Access Compliance Report

Public Rights-of-Way

(Curb Ramps)

Intersection ID: N/A	Main Street: MORABLIN_DR	Cross Street: CARAGANA_CT	Location: S
ADA ID: BB0C3A79CEEC	Ramp Type: PerpDiag	Initial Pass/Fail: Fail	Overall Compliance: No
Severity Score: 35			
Codes/Mitigation Info/Possible Solution		Field Measurements/Component Compliance

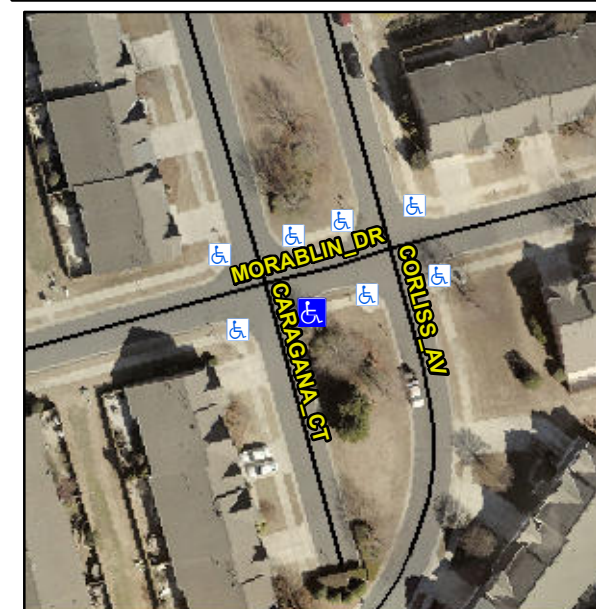
Not Found, R304.5.1

Compliance	Description	Data	Compliance	Description	Data
N/A	Ramp Length (in)	89.0	Yes	Ramp Slope (%)	5.2
No	Ramp Width (in)	30.0	Yes	Ramp XSlope (%)	1.8
N/A	Flare Type LT	N/A	N/A	Flare Type RT	N/A
N/A	Flare Slope LT (%)	N/A	N/A	Flare Slope RT (%)	N/A
N/A	Flare Traversable LT?	N/A	N/A	Flare Traversable RT?	N/A
N/A	Landing Length (in)	N/A	N/A	DWS Provided?	N/A
N/A	Landing Width (in)	N/A	N/A	DWS Contrast?	N/A
N/A	Landing Slope (%)	N/A	N/A	DWS Length (in)	N/A
N/A	Landing X Slope (%)	N/A	N/A	DWS Full Width?	N/A
N/A	Landing Curb? (Y/N)	N/A	N/A	DWS Offset (in)	N/A
N/A	Shared Landing?	N/A			
N/A	Gutter Ponding?	N/A	N/A	Gutter Slope (%)	N/A
N/A	Gutter Lip Ht (in)	N/A	N/A	Gutter X Slope (%)	N/A
N/A	Painted X Walk1?	No	N/A	Painted X Walk2?	No
	X Walk 1 Direction	To N		X Walk 2 Direction	To W
N/A	X Walk 1 Width (in)	N/A	N/A	X Walk 2 Width (in)	N/A
	X Walk 1 Slope (%)	2.4		X Walk 2 Slope (%)	4.1
	X Walk 1 X Slope (%)	3.7		X Walk 2 X Slope (%)	5.1

Remove & Replace Curb Ramp With Two New Directional Ramps or Equivalent.
